HILLSTA

UNIT #38 (Annex B3)

TYPE T2a

BP NO. : A1606-00001-2011 BP01

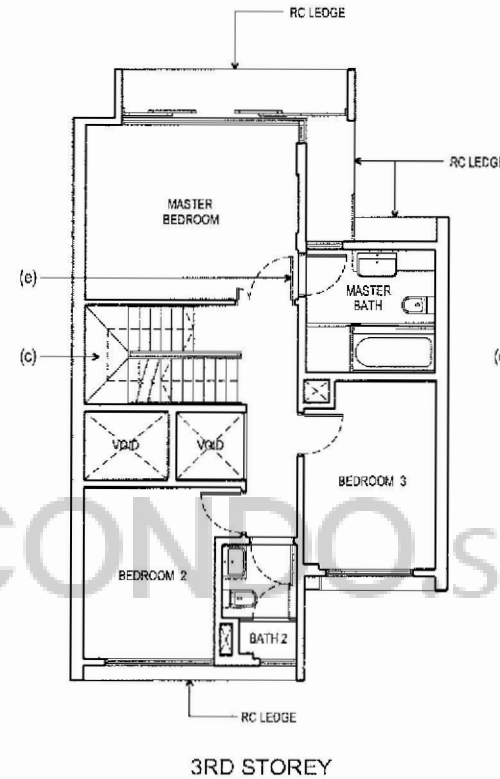
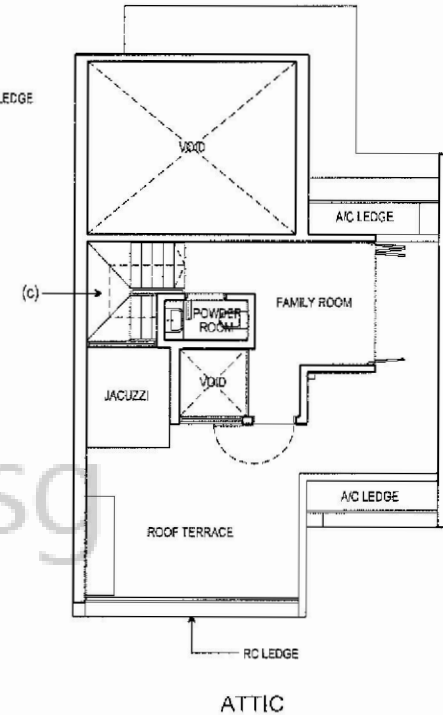
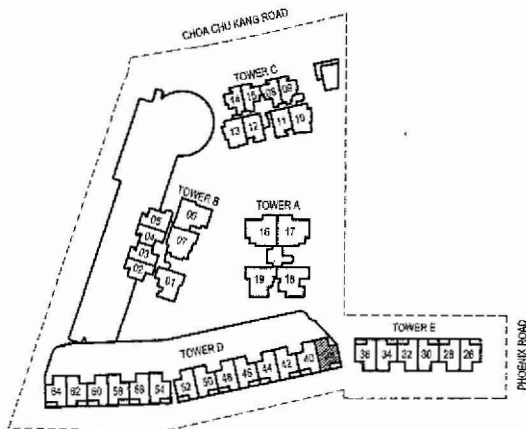
- CHANGES TO BE SUBMITTED IN THE NEXT BP AMENDMENT ARE SHOWN IN THESE PLANS:
- (a) RELOCATION OF METERING
 - (b) NUMBER OF STEPS AT OPEN TERRACE
 - (c) STEPS AT LANDING HAD BEEN RELOCATED TO UPPER FLIGHT
 - (d) REMOVAL OF WINDOWS AND ADDITION OF MECHANICAL VENTILATION
 - (e) 2 LEAVES TYPE DOOR CHANGED TO 1.5 LEAF TYPE DOOR

UNIT #40 (Annex B3)

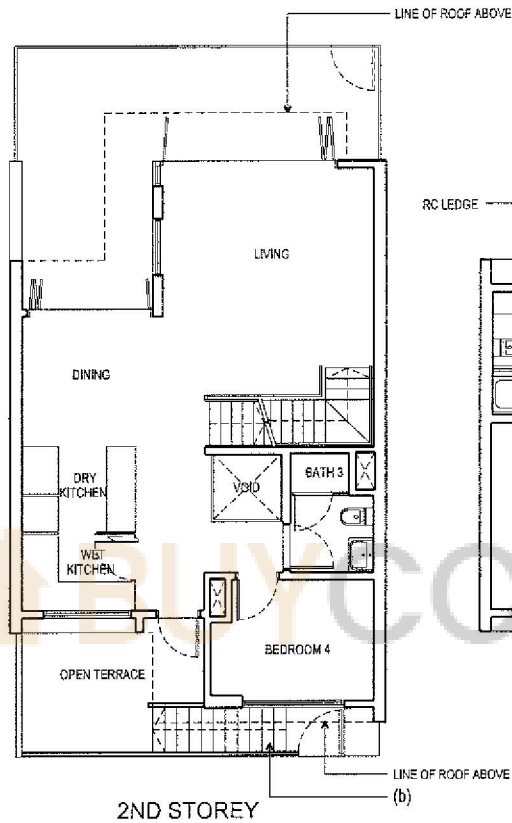
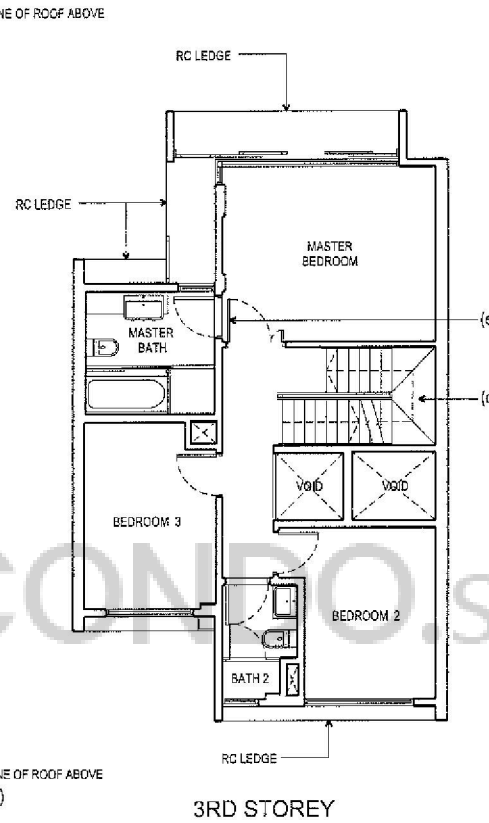
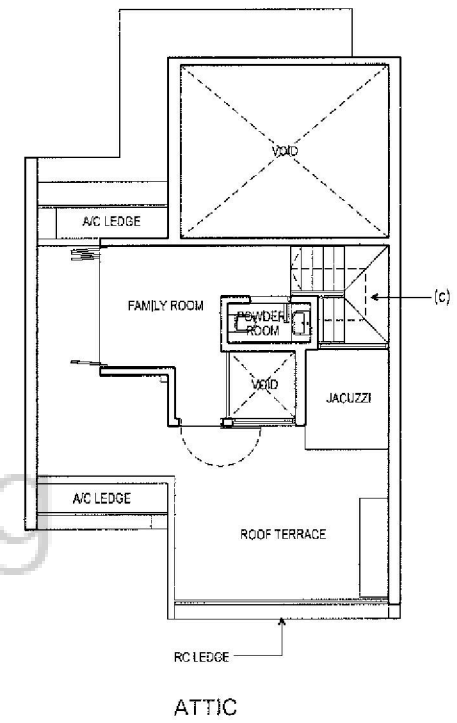
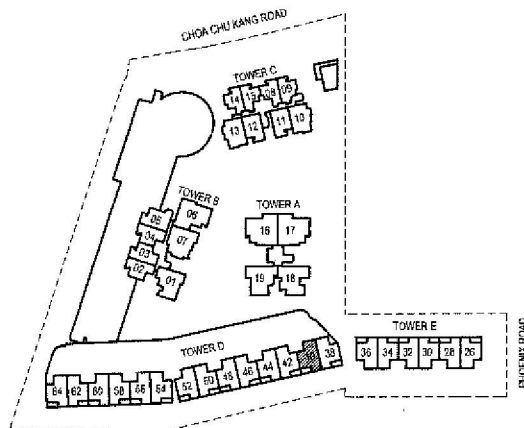
CHANGES TO BE SUBMITTED IN THE NEXT BP AMENDMENT ARE SHOWN IN THESE PLANS:

- (a) RELOCATION OF METERING
- (b) NUMBER OF STEPS AT OPEN TERRACE
- (c) STEPS AT LANDING HAD BEEN RELOCATED TO UPPER FLIGHT
- (d) REMOVAL OF WINDOWS AND ADDITION OF MECHANICAL VENTILATION
- (e) 2 LEAVES TYPE DOOR CHANGED TO 1.5 LEAF TYPE DOOR

UNIT #42 (Annex B3)

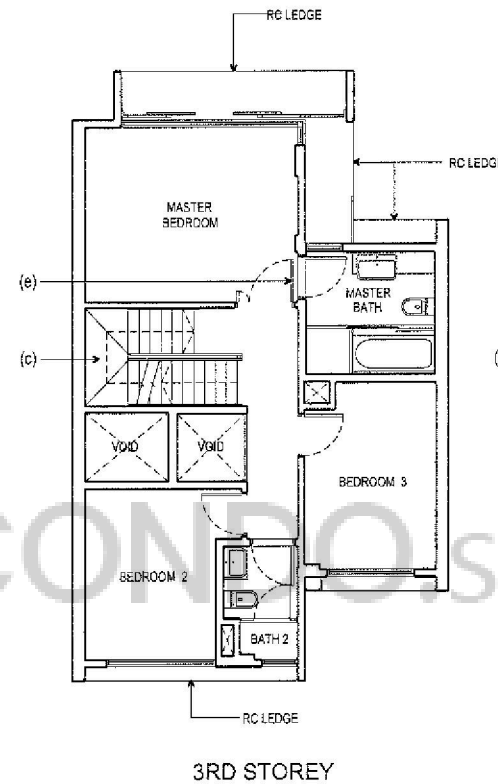
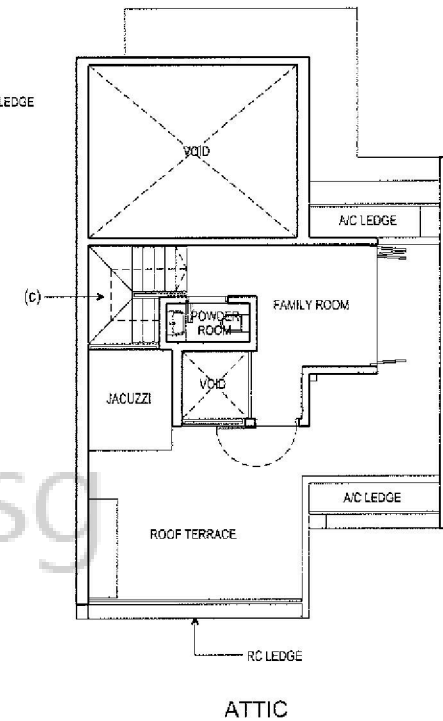
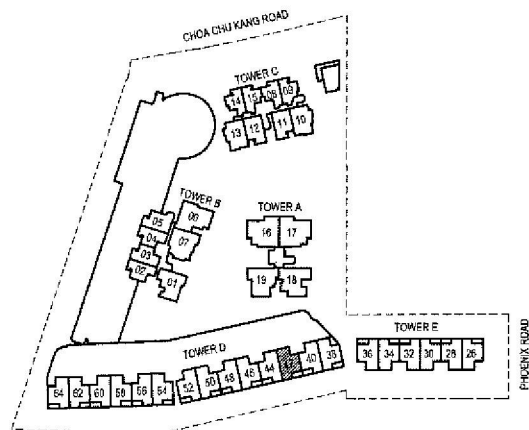
CHANGES TO BE SUBMITTED IN THE NEXT BP
AMENDMENT ARE SHOWN IN THESE PLANS:

- (a) RELOCATION OF METERING
- (b) NUMBER OF STEPS AT OPEN TERRACE
- (c) STEPS AT LANDING HAD BEEN RELOCATED TO UPPER FLIGHT
- (d) REMOVAL OF WINDOWS AND ADDITION OF MECHANICAL VENTILATION
- (e) 2 LEAVES TYPE DOOR CHANGED TO 1.5 LEAF TYPE DOOR

UNIT #44 (Annex B3)

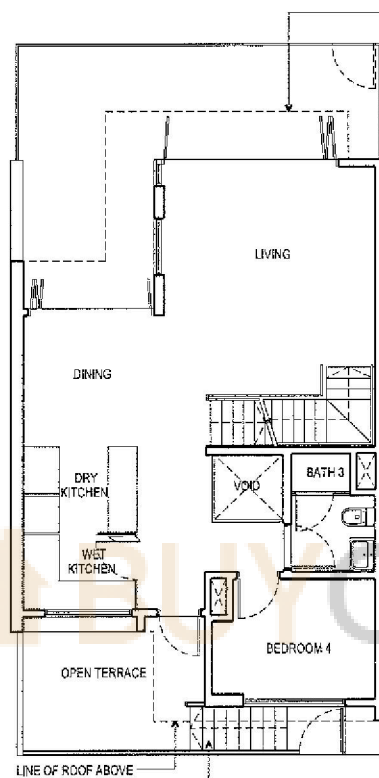
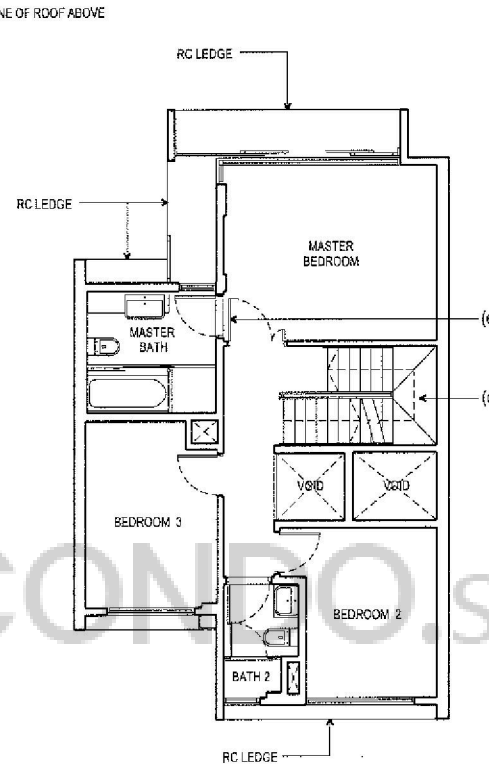
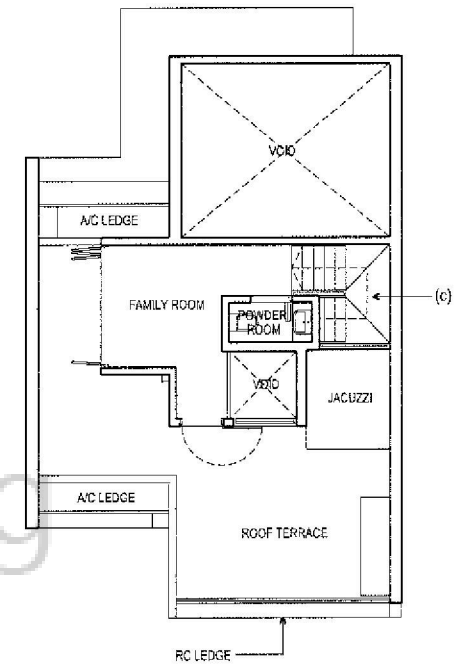
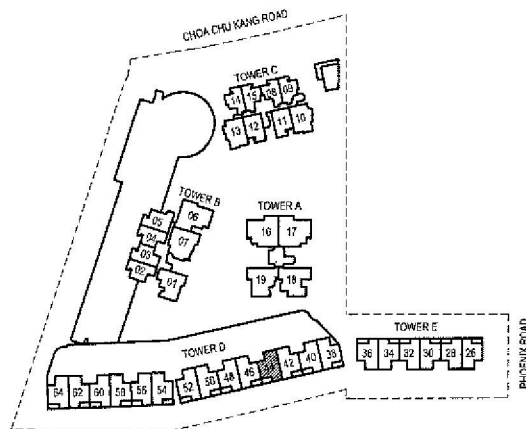
CHANGES TO BE SUBMITTED IN THE NEXT BP
AMENDMENT ARE SHOWN IN THESE PLANS:

- (a) RELOCATION OF METERING
- (b) NUMBER OF STEPS AT OPEN TERRACE
- (c) STEPS AT LANDING HAD BEEN RELOCATED
TO UPPER FLIGHT
- (d) REMOVAL OF WINDOWS AND ADDITION OF
MECHANICAL VENTILATION
- (e) 2 LEAVES TYPE DOOR CHANGED TO
1.5 LEAF TYPE DOOR

UNIT #46 (Annex B3)

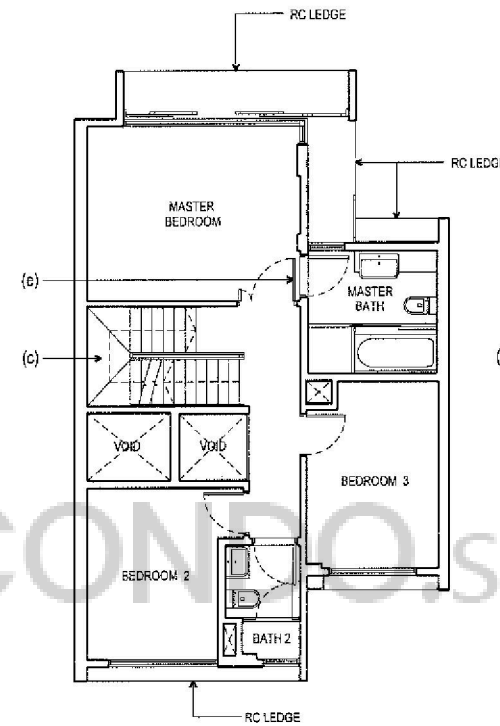
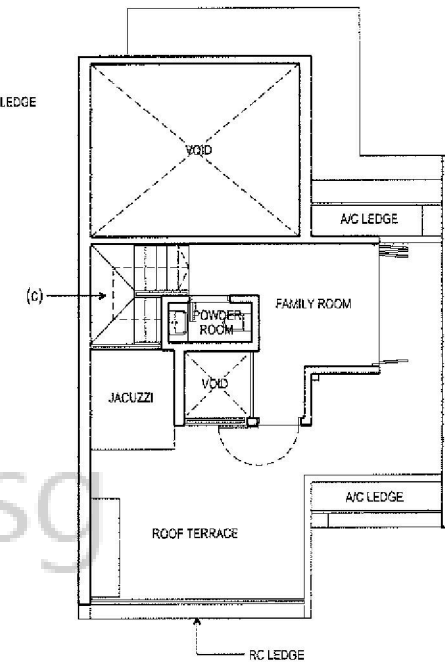
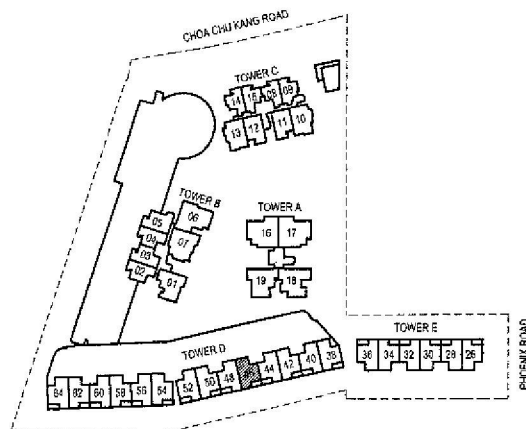
CHANGES TO BE SUBMITTED IN THE NEXT BP
AMENDMENT ARE SHOWN IN THESE PLANS:

- (a) RELOCATION OF METERING
- (b) NUMBER OF STEPS AT OPEN TERRACE
- (c) STEPS AT LANDING HAD BEEN RELOCATED TO UPPER FLIGHT
- (d) REMOVAL OF WINDOWS AND ADDITION OF MECHANICAL VENTILATION
- (e) 2 LEAVES TYPE DOOR CHANGED TO 1.5 LEAF TYPE DOOR

UNIT #48 (Annex B3)

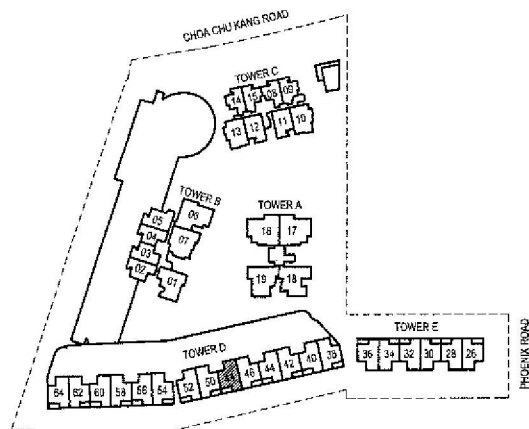
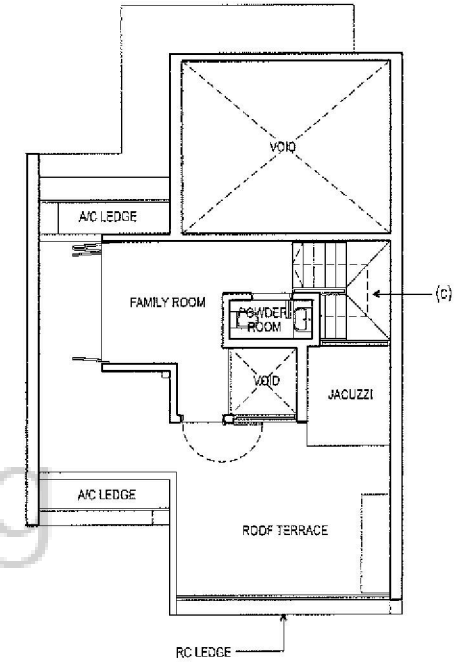
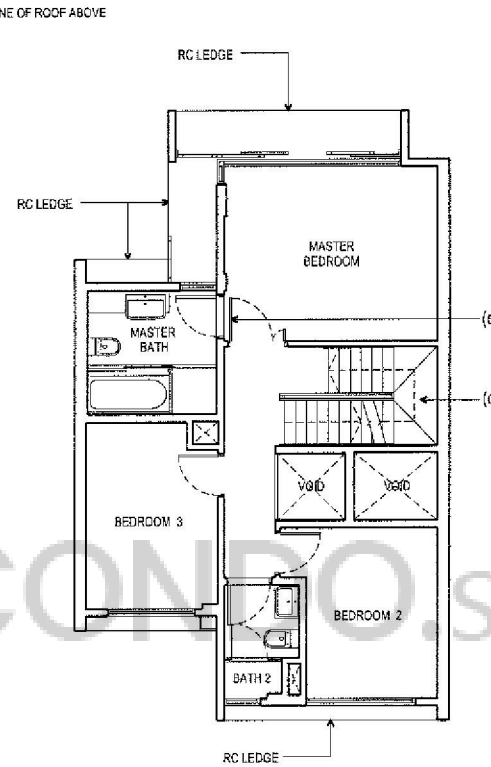
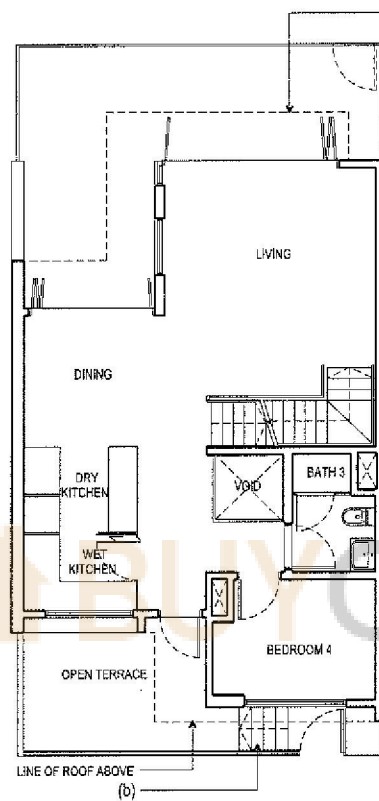
CHANGES TO BE SUBMITTED IN THE NEXT BP AMENDMENT ARE SHOWN IN THESE PLANS:

- (a) RELOCATION OF METERING
- (b) NUMBER OF STEPS AT OPEN TERRACE
- (c) STEPS AT LANDING HAD BEEN RELOCATED TO UPPER FLIGHT
- (d) REMOVAL OF WINDOWS AND ADDITION OF MECHANICAL VENTILATION
- (e) 2 LEAVES TYPE DOOR CHANGED TO 1.5 LEAF TYPE DOOR

UNIT #50 (Annex B3)

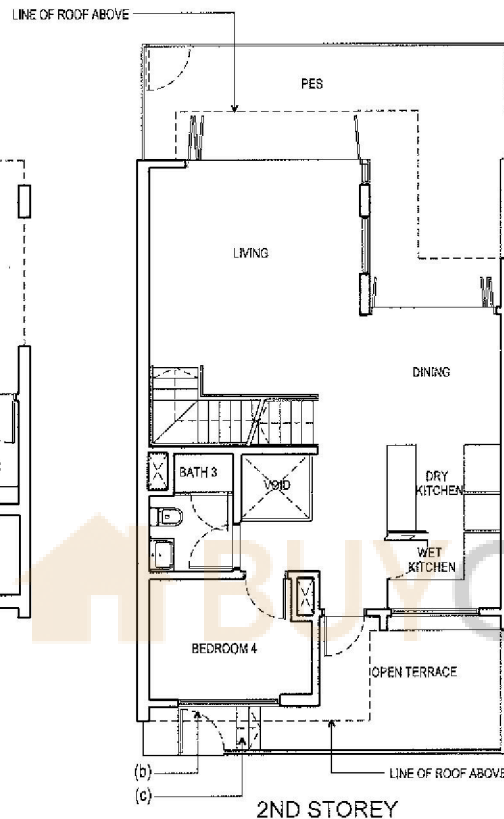
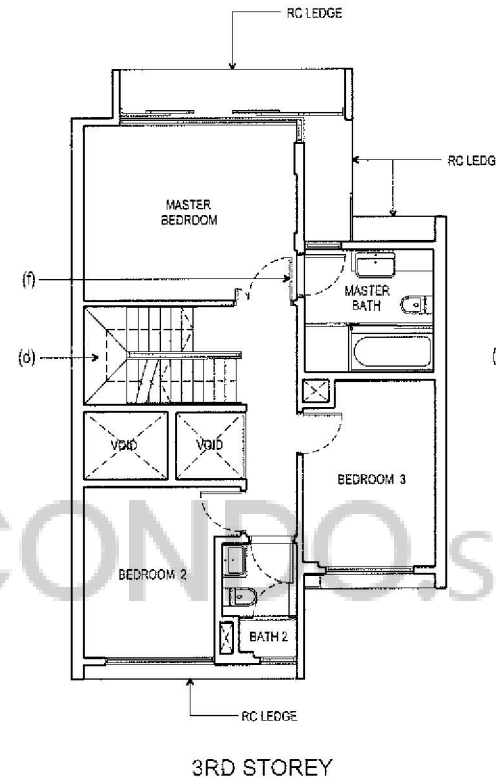
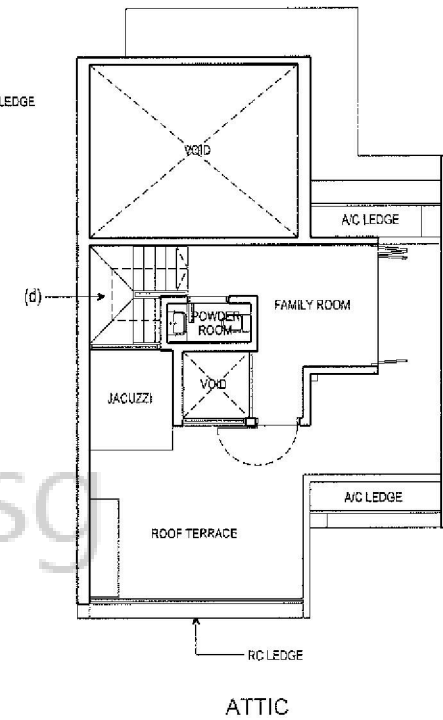
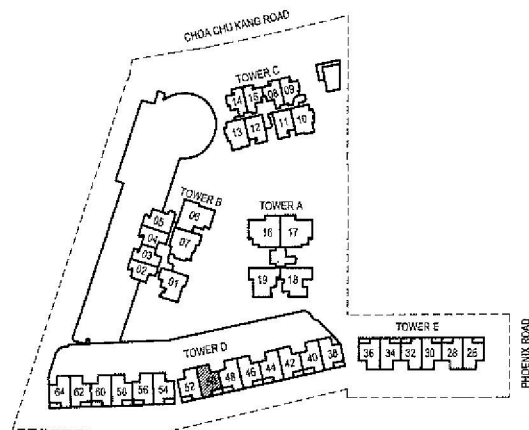
CHANGES TO BE SUBMITTED IN THE NEXT BP
AMENDMENT ARE SHOWN IN THESE PLANS:

- (a) RELOCATION OF METERING
- (b) RELOCATION OF ENTRANCE GATE
- (c) NUMBER OF STEPS AT OPEN TERRACE
- (d) STEPS AT LANDING HAD BEEN RELOCATED TO UPPER FLIGHT
- (e) REMOVAL OF WINDOWS AND ADDITION OF MECHANICAL VENTILATION
- (f) 2 LEAVES TYPE DOOR CHANGED TO 1.5 LEAF TYPE DOOR

UNIT #52 (Annex B3)

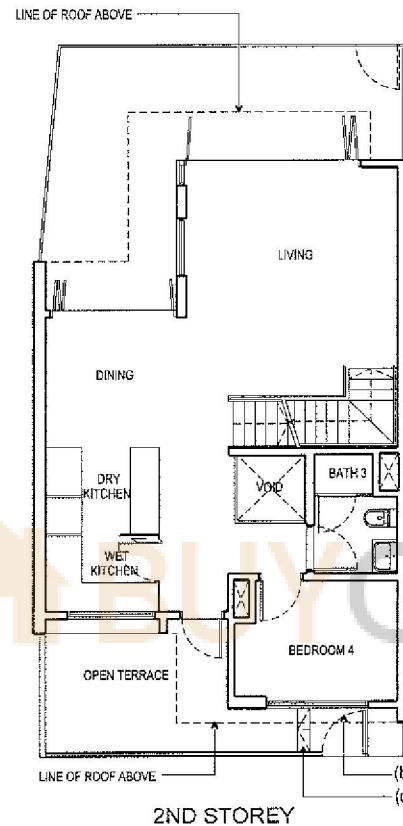
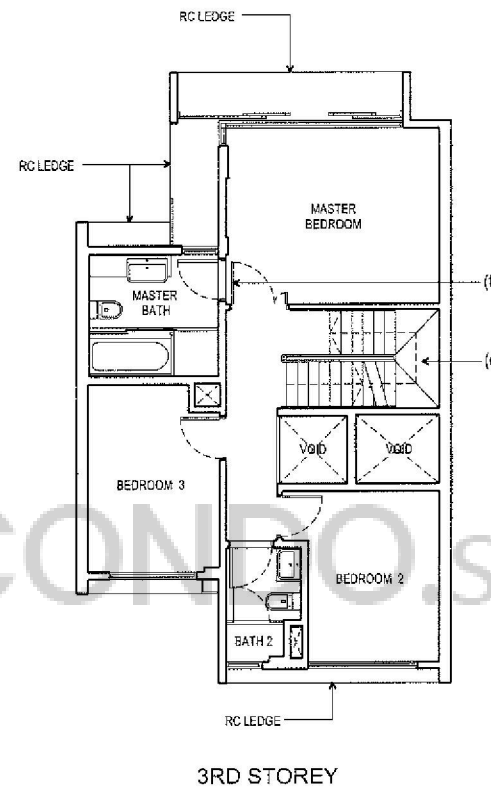
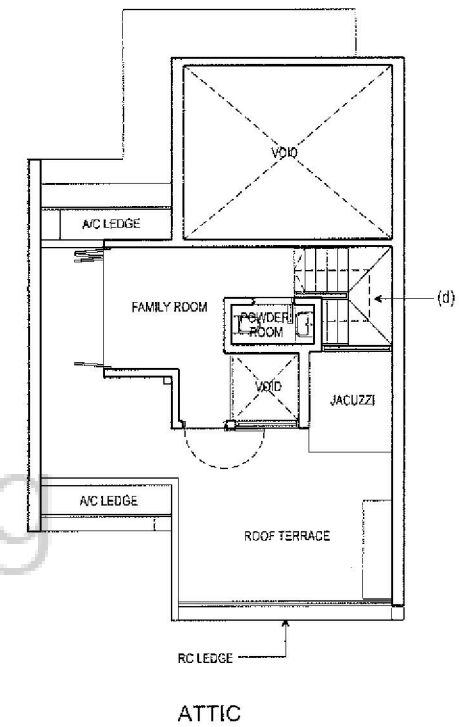
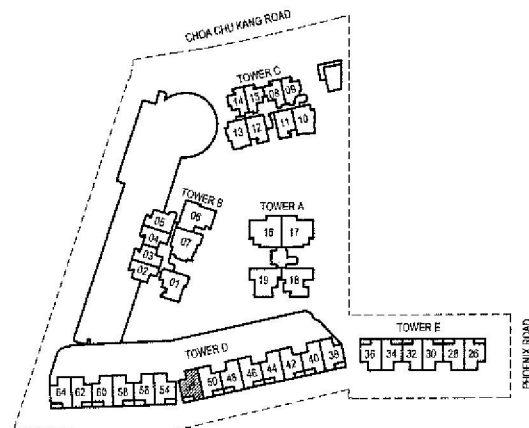
CHANGES TO BE SUBMITTED IN THE NEXT BP AMENDMENT ARE SHOWN IN THESE PLANS:

- (a) RELOCATION OF METERING
- (b) RELOCATION OF ENTRANCE GATE
- (c) RELOCATION OF STAIRCASE AT OPEN TERRACE
- (d) STEPS AT LANDING HAD BEEN RELOCATED TO UPPER FLIGHT
- (e) REMOVAL OF WINDOWS AND ADDITION OF MECHANICAL VENTILATION
- (f) 2 LEAVES TYPE DOOR CHANGED TO 1.5 LEAF TYPE DOOR

UNIT #54 (Annex B3)

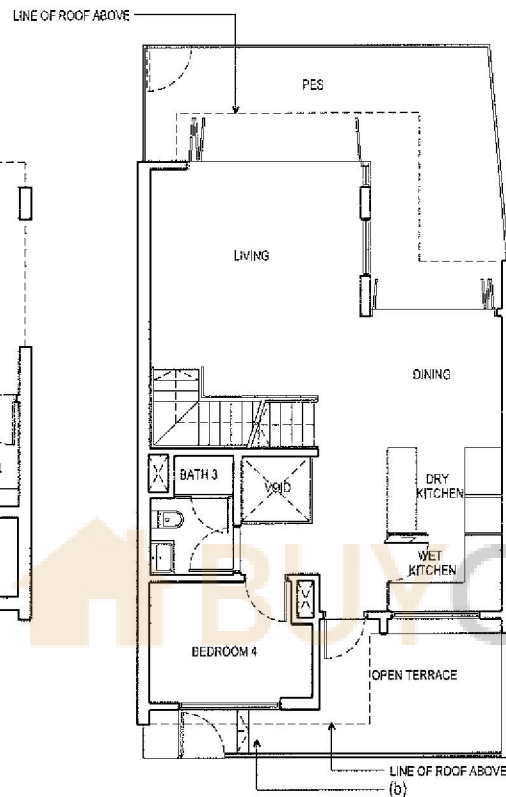
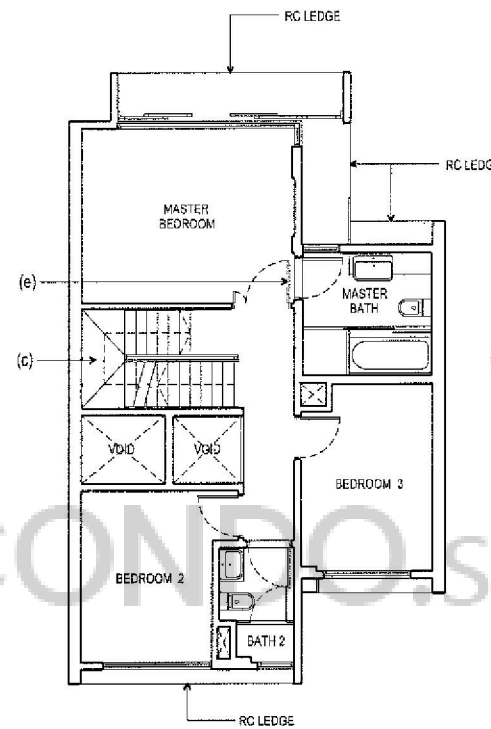
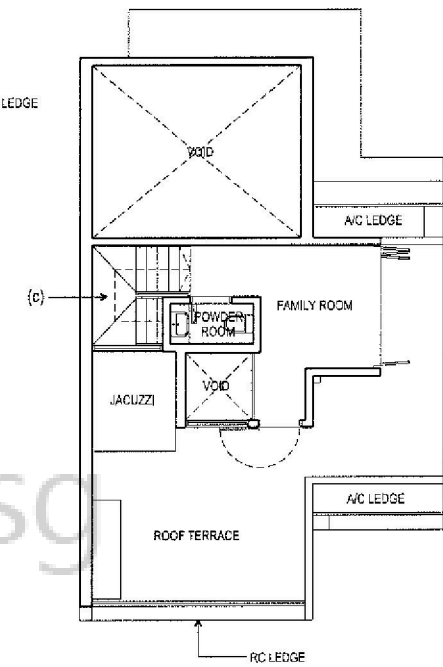
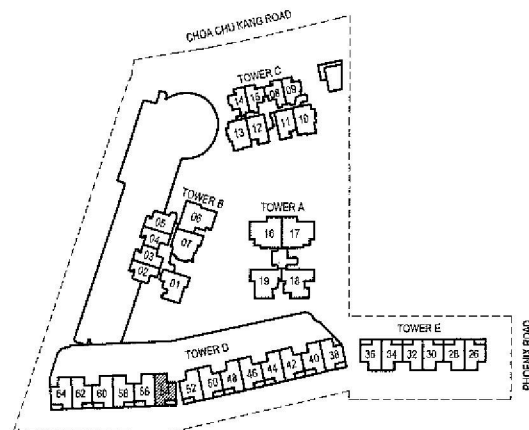
CHANGES TO BE SUBMITTED IN THE NEXT BP AMENDMENT ARE SHOWN IN THESE PLANS:

- (a) RELOCATION OF METERING
- (b) NUMBER OF STEPS AT OPEN TERRACE
- (c) STEPS AT LANDING HAD BEEN RELOCATED TO UPPER FLIGHT
- (d) REMOVAL OF WINDOWS AND ADDITION OF MECHANICAL VENTILATION
- (e) 2 LEAVES TYPE DOOR CHANGED TO 1.5 LEAF TYPE DOOR
